M2J1 Merge and Diverge Assessment

This document was prepared following Kent County Council's (KCC) request to examine the impacts of the Local Plan upon the slip road merges and diverges at M2J1.

(2) M2 EASTBOUND: MERGE

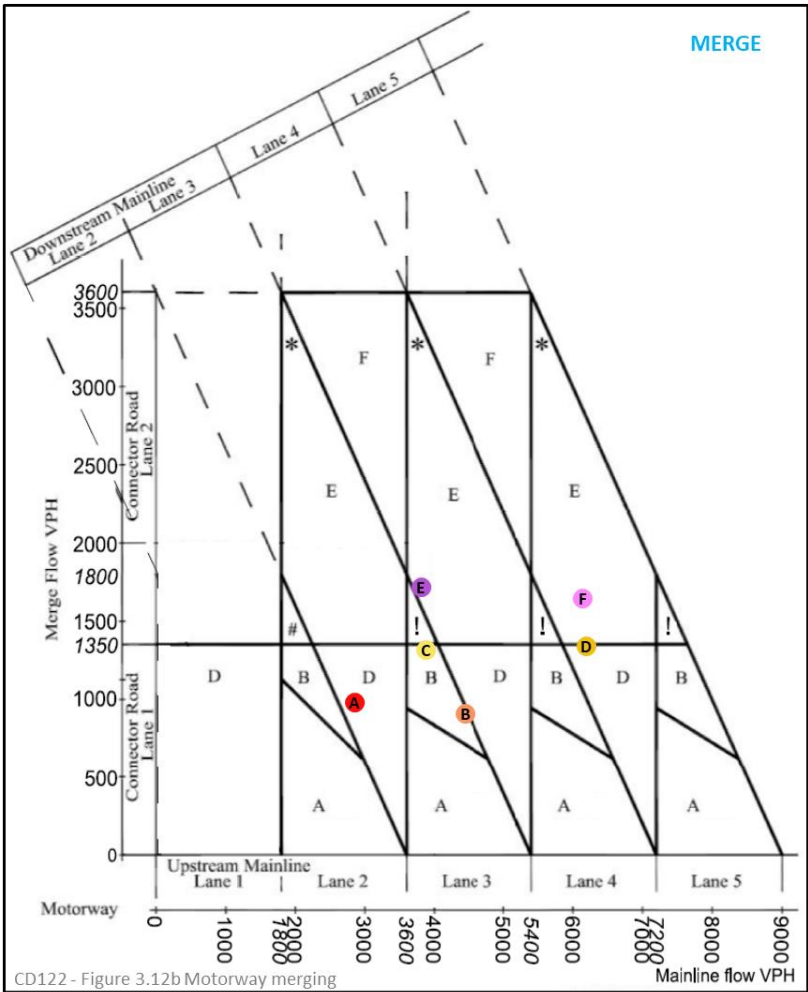
- The M2J1 EB merge (on-slip) is currently type D layout.
- By the Do Something, an increase is required from type D to a type E*.

CD122 - Figure 3.14g Layout E Option 1 - lane gain with ghost island offside merge

(3) A289 NORTHBOUND: MERGE

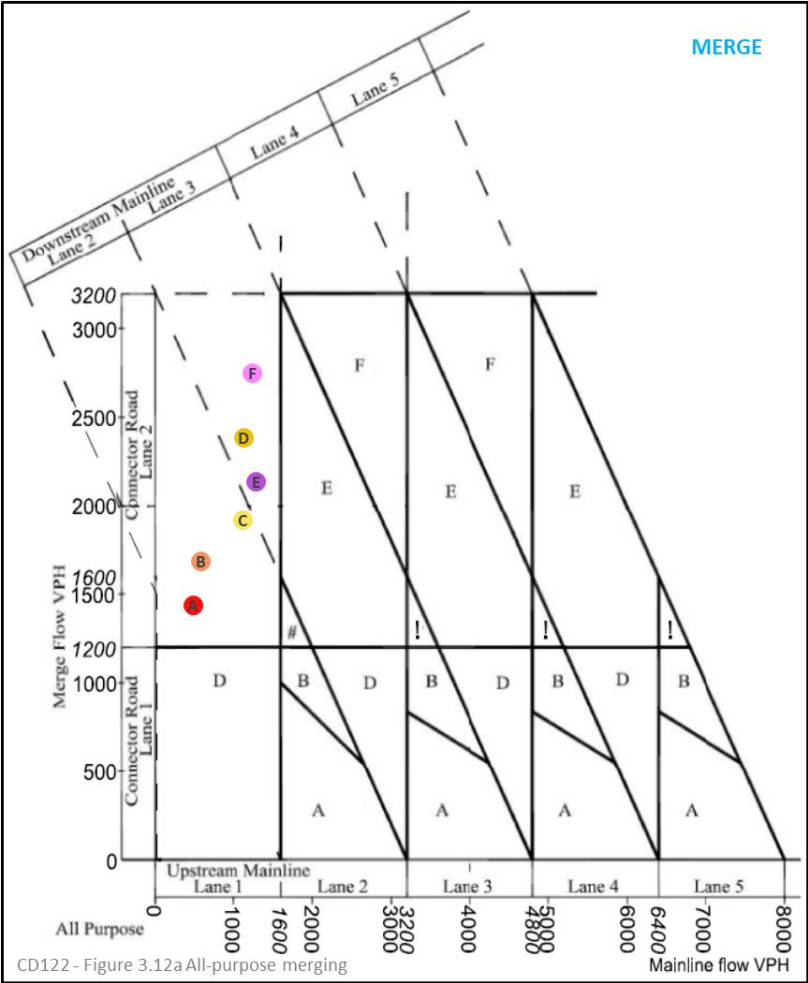
- This is a complex merging situation where merging flow is higher than mainline flow. It is recommended that an E type layout would be more suitable here, but this is not due to the local plan scenarios as there is no change in provision likely to be required from the reference case.

CD122 - Figure 3.14g Layout E Option 1 - lane gain with ghost island offside merge

Figure 1: M2 J1 Mitigation Snippet Taken from Stantec Drawing

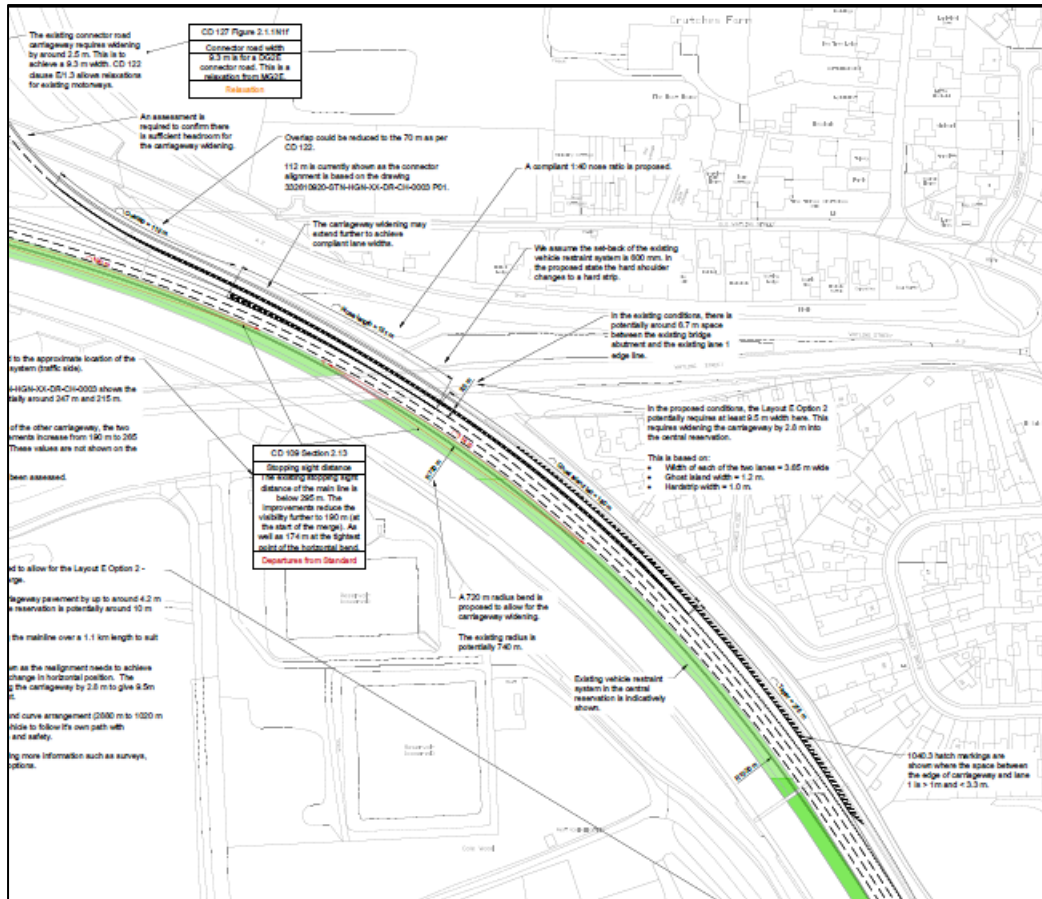
According to the Design Manual for Road and Bridges, the M2 Eastbound Merge required an improvement to a Type E layout. Figure below shows the proposed type E layout, provided by Stantec. Jacobs can confirm the layout provided by Stantec meets the requirements set out in the DMRB, but as this is a Stantec design, Jacobs cannot comment further. The proposed mitigation drawings can be found in Appendix A.

Stantec have provided a design drawing to Medway which shows a layout which appears to satisfy DMRB and National Highways requirements. As this is a Stantec design, Jacobs cannot comment further on the design, and it is recommended that this design is reviewed with both Stantec and National Highways.

FEASIBILITY STUDY
A289 TO M2 MERGE (SB)
SCHEME D
IMPROVING THE MERGE & REALIGNING THE M2

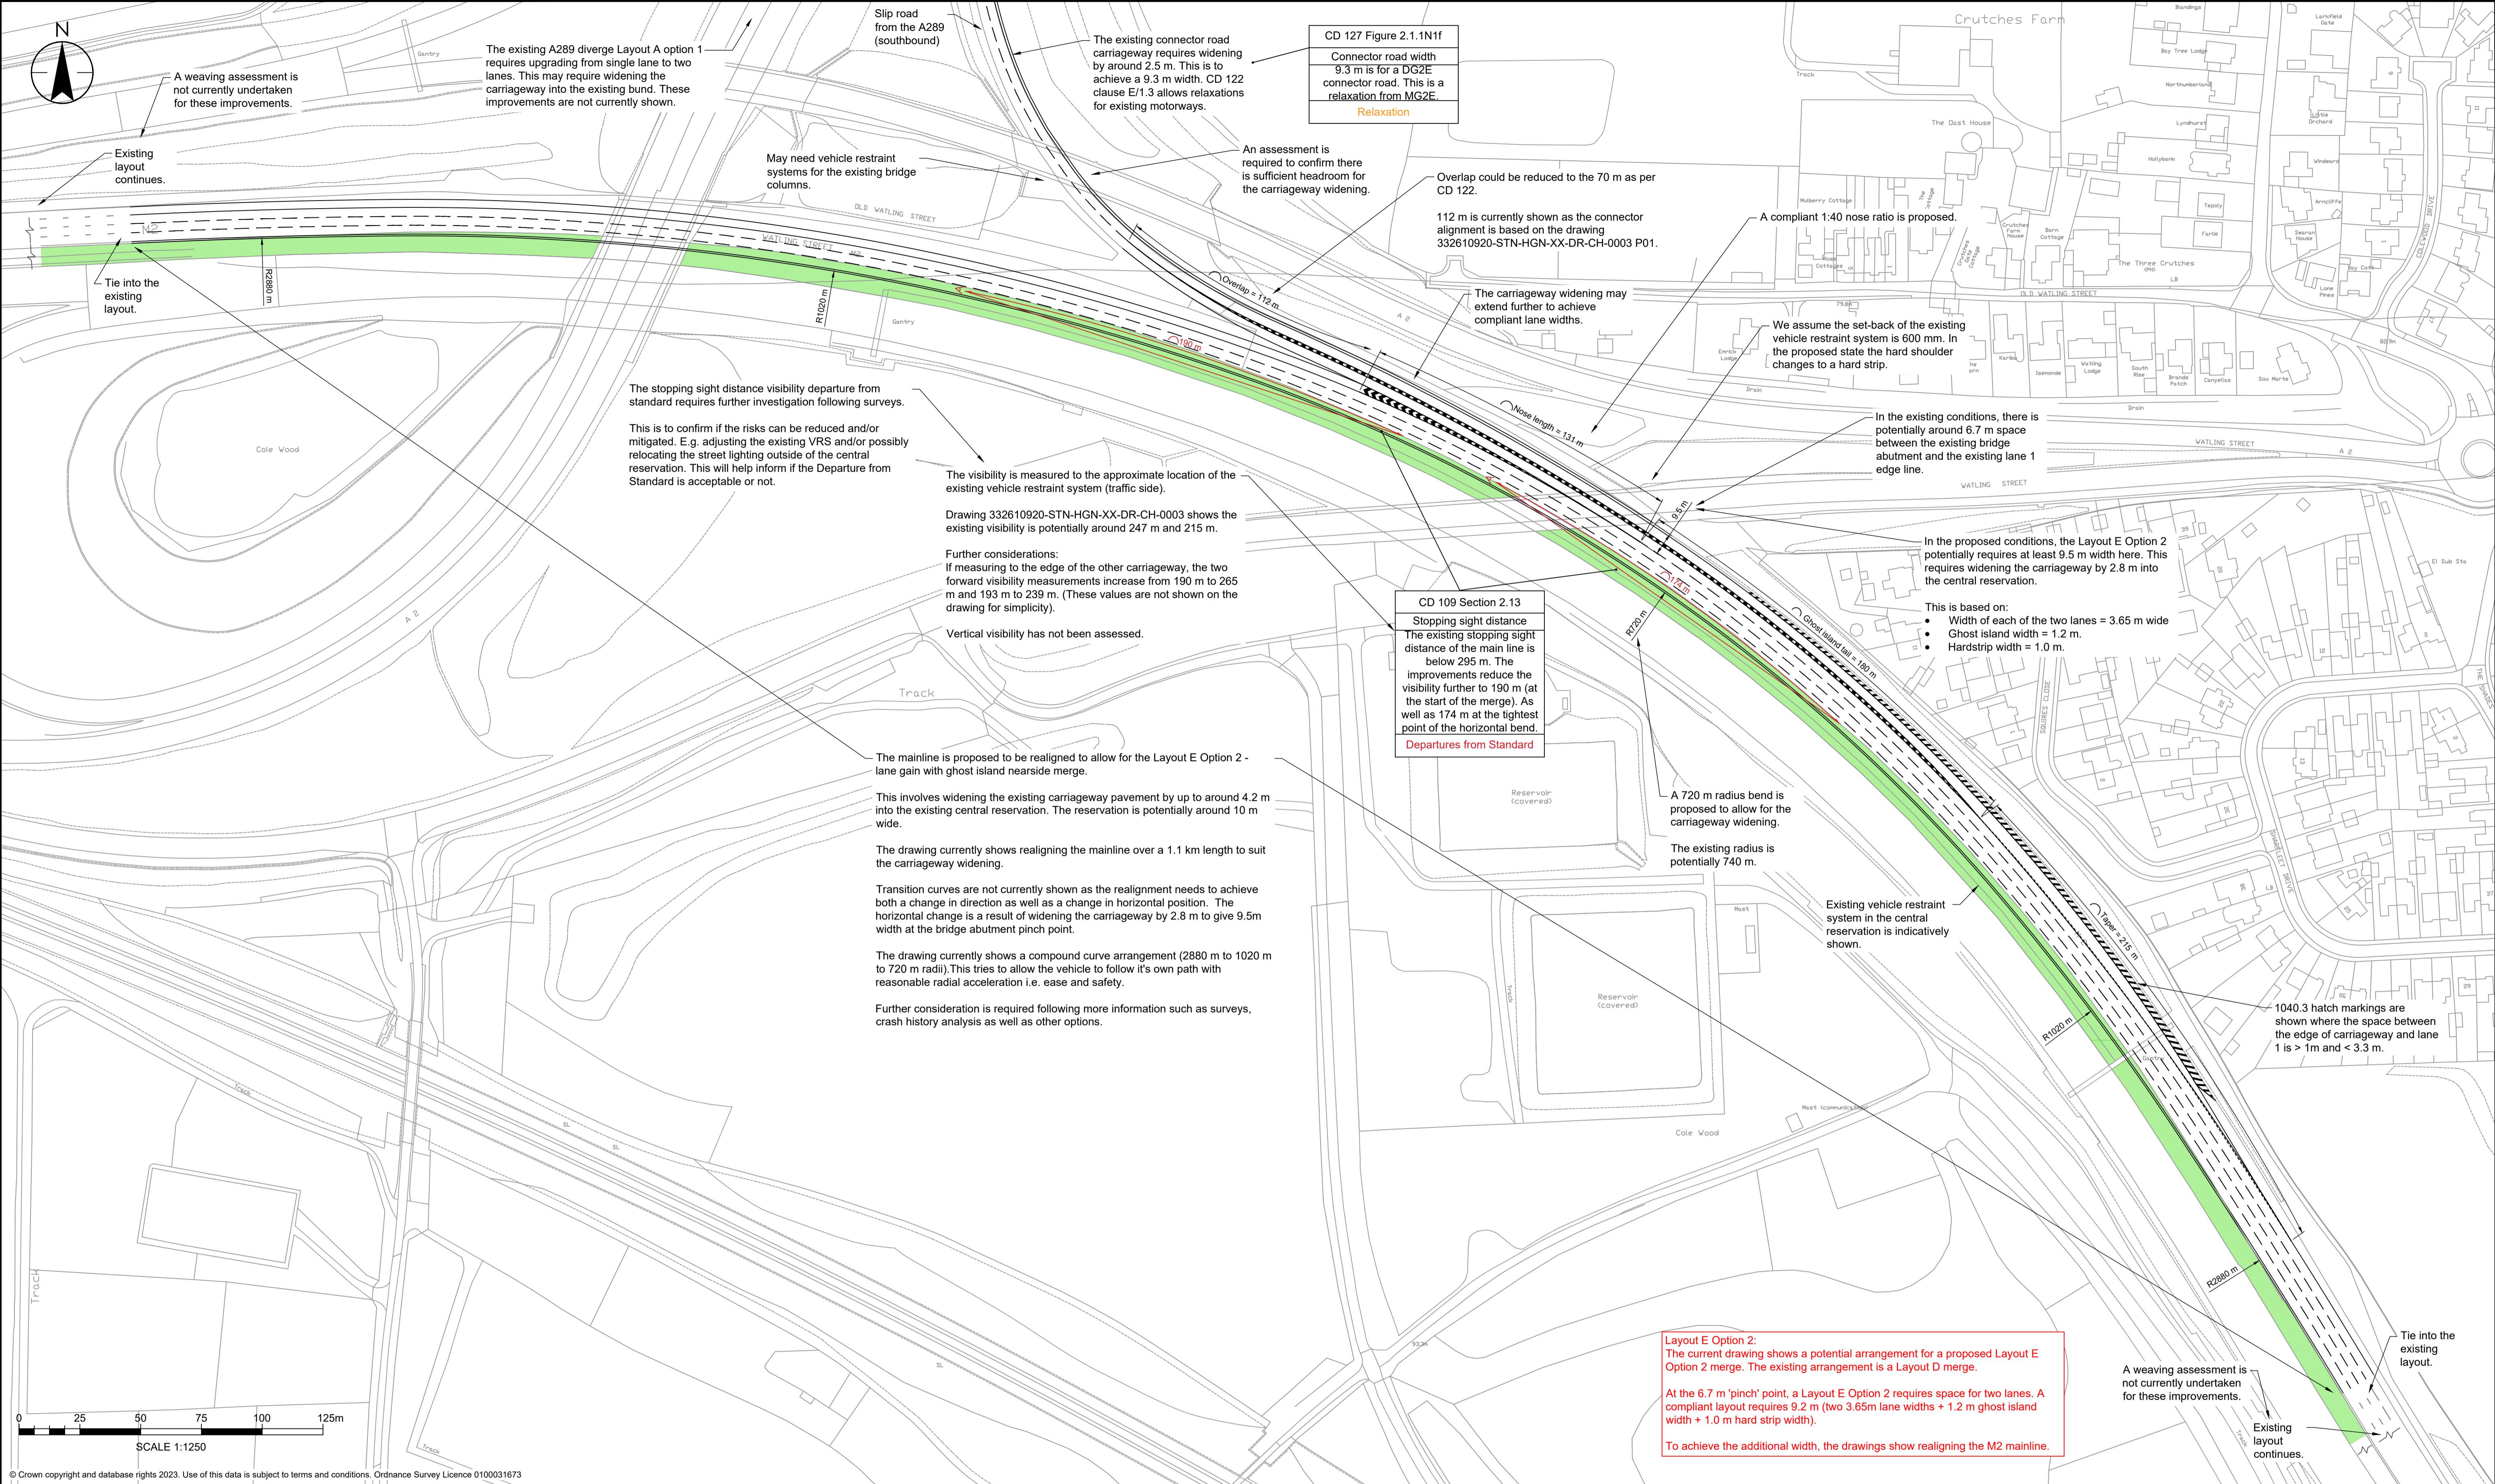
CD 127 Figure 2.1.1N1f
Connector road width
9.3 m is for a DG2E
connector road. This is a
relaxation from MG2E.
Relaxation

CD 109 Section 2.13
Stopping sight distance
The existing stopping sight
distance of the main line is
below 295 m. The
improvements reduce the
visibility further to 190 m (at
the start of the merge). As
well as 174 m at the tightest
point of the horizontal bend.
Departures from Standard

Layout E Option 2:
The current drawing shows a potential arrangement for a proposed Layout E
Option 2 merge. The existing arrangement is a Layout D merge.

At the 6.7 m 'pinch' point, a Layout E Option 2 requires space for two lanes. A
compliant layout requires 9.2 m (two 3.65m lane widths + 1.2 m ghost island
width + 1.0 m hard strip width).

To achieve the additional width, the drawings show realigning the M2 mainline.
